Addendum 01

To: Bidding General Contractors and Subcontractors
From: Ben Walter, CWS Architects
Regarding: **St. Francis Apartments Phase 2** – Waterville, Maine
Subject: **Addendum 01**

Modify the previously issued documents dated December 4, 2017 and any previously issued addenda, if applicable, as follows:

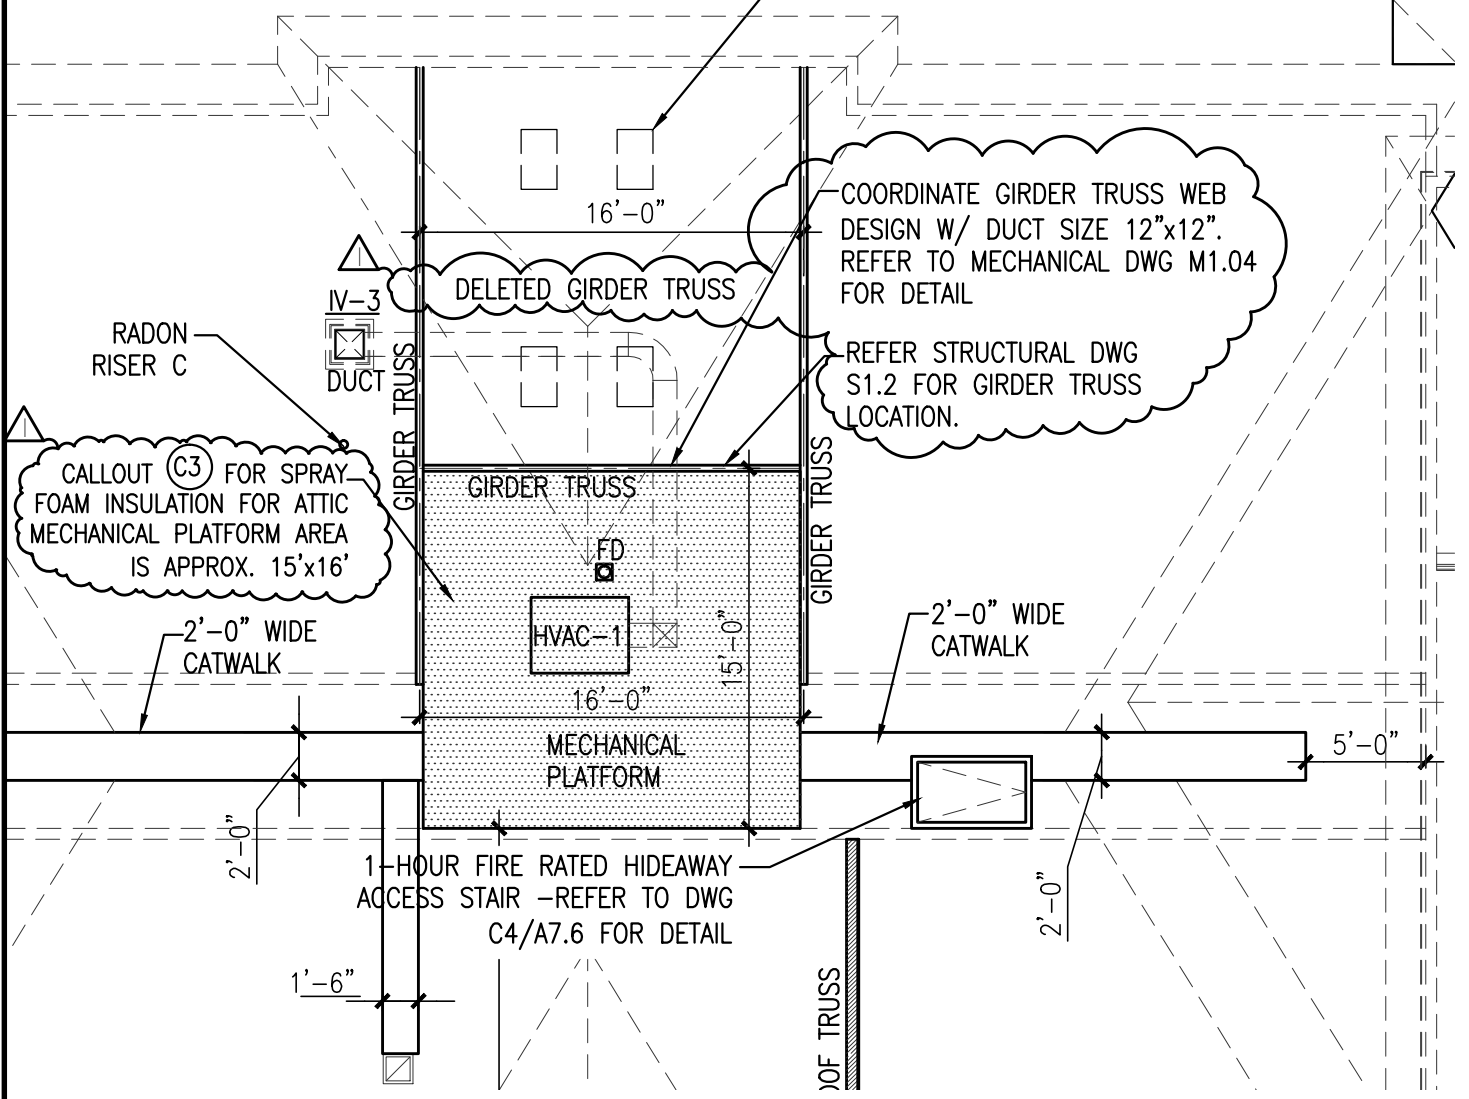
- (2) Add note to clarify callout 'C3' for spray foam insulation at the attic mechanical platform. The area of the platform is approx. 15'X16' as indicated on attached sketch SKA-02.

DRAWING
SKA-01

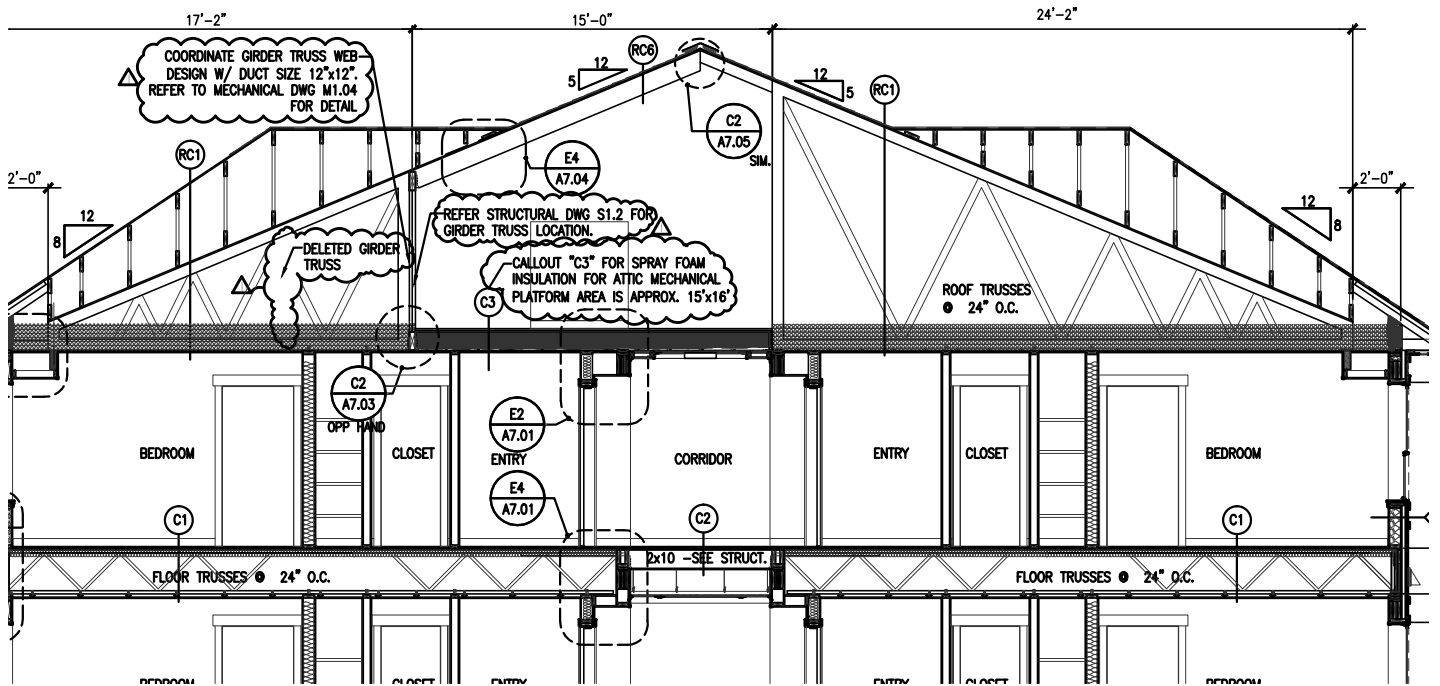
6. Modify Drawing A1.04 as follows:
 - (1) Delete one girder truss and add note to coordinate girder truss web design with mechanical duct size as indicated on sketch SKA-01, attached.

- (2) Add note to clarify callout 'C3' for spray foam insulation at the attic mechanical platform. The area of the platform is approx. 15'X16' as indicated on attached sketch SKA-01.

7. Modify Drawing A5.02 as follows:
 - (1) Delete one girder truss and add note to coordinate girder truss web design with mechanical duct size as indicated on attached sketch SKA-01
